# FLORIDA DEPARTMENT OF Environmental Protection

Re: Warning Letter #WL20-200SW25SWD  
Hardee County Regional Landfill  
WACS ID: 40612  
Hardee County

**Florida Department of  
Environmental Protection  
Inspection Checklist**

**Facility Name:** HARDEE COUNTY REGIONAL LANDFILL  
**On-site Inspection Start Date:** 11/18/2020  
**On-site Inspection End Date:** 11/18/2020  
**WACS No.:** 40612  
**Facility Street Address:** 685 AIRPORT ROAD  
**City:** WAUCHULA  
**County Name:** HARDEE  
**Zip:** 33873

**B) Fill Sequence 4****B) Fill Sequence 4****C) Distance Between Edge & Lifts**

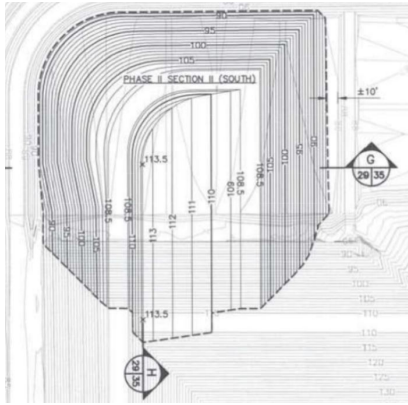
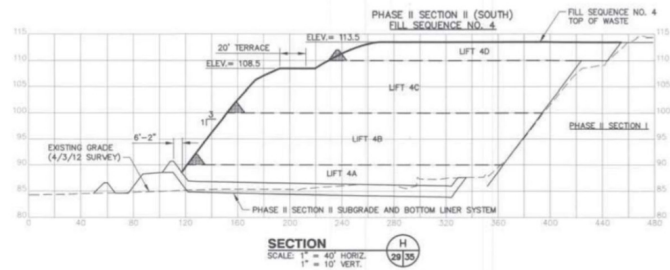
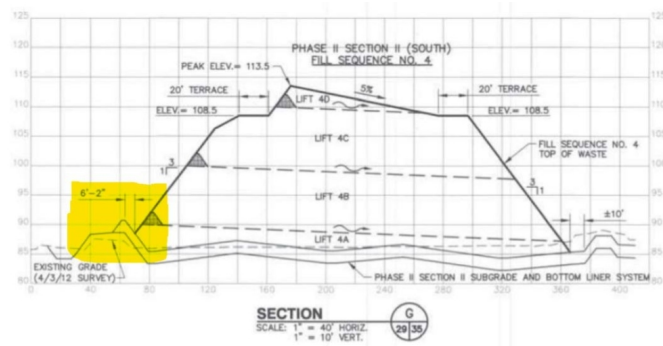
B) Per section K.2.f.2 of the facility's Operation Plan, Fill Sequence 4 involves the filling of the south portion of Phase II Section II. During the inspection, it appeared that the top lifts of Fill Sequence 4, elevations between 108.5 and 113.5, were not filled in entirely to connect this portion of Phase II Section II to the side slope of Phase II Section I. On the Fill Sequence 4 drawings, these elevations are contained within lifts 4C and 4D and are represented by the attachments entitled "Fill Sequence 4".

C) At the time of the inspection, it was unclear if the south and center portions of Phase II Section II were offset from the edge of the disposal at the correct distance. Per the Fill Sequence 4 drawings, it appears that each lift within these portions of Phase II Section II must be offset six feet and two inches from the edge of disposal, as depicted in the attachment entitled "Distance Between Edge & Lifts".

B) Please provide photo documentation demonstrating that the waste lifts contained between the elevations of 108.5 and 113.5 were filled in accordance with the Fill Sequence 4 drawings. In addition, following the filling of these lifts, please provide a survey of the landfill to demonstrate that Fill Sequence 4 has been completed in accordance with the operation plan and drawings. Please provide this documentation to the Department within 30 calendar days of the date listed on the attached Warning Letter. Please also see Item 2.19 for additional information regarding this matter.

C) Please provide documentation demonstrating that the distance between the waste and the edge of disposal meets the distance requirement outlined in Fill Sequence 4 for the south and center portions of Phase II Section II. This documentation can be presented within the landfill survey requested in Item A above. Please provide this documentation to the Department within 30 calendar days of the date listed on the attached Warning Letter.

A) Area Needs Intermediate Cover

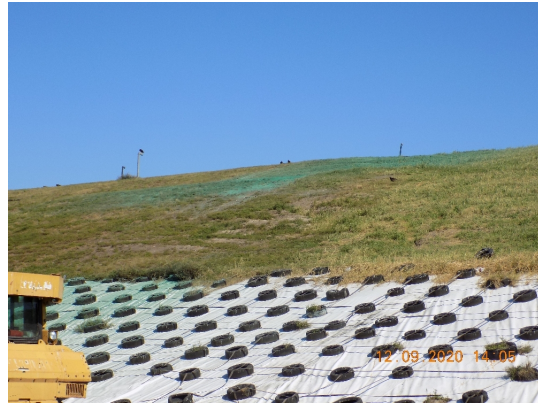
Explanation: A) Please see Item 2.13, Item B for information regarding this Violation. Per Item 2.13, Item B, the top lifts of the south portion of Phase II Section II must be filled in with waste. Intermediate cover must be applied in this area in accordance with Condition C.8.b. of the facility's Permit (No. 38414-016-SO/01) and Section K.7.g of the Operation Plan.

A) Documentation demonstrating that intermediate cover was applied to the top lifts of the south portion of Phase II Section II.

A) Leachate Discharge

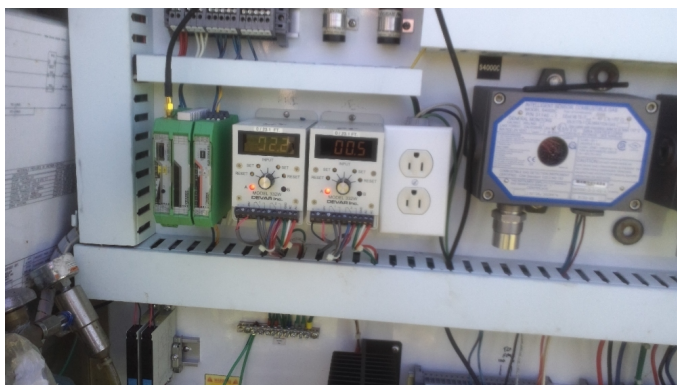
- Explanation:
- A) During the inspection, a flex hose connected to the Leachate Collection System (LCS) and Leachate Detection System (LDS) riser pipes discharging leachate. The pump was turned off immediately by facility personnel. Photo documentation demonstrating that the connector for the flex hose that was discharging during the inspection was replaced was provided via email on December 7, 2020. This is the second leachate discharge observed by Department at this facility within the last 1.5 years.
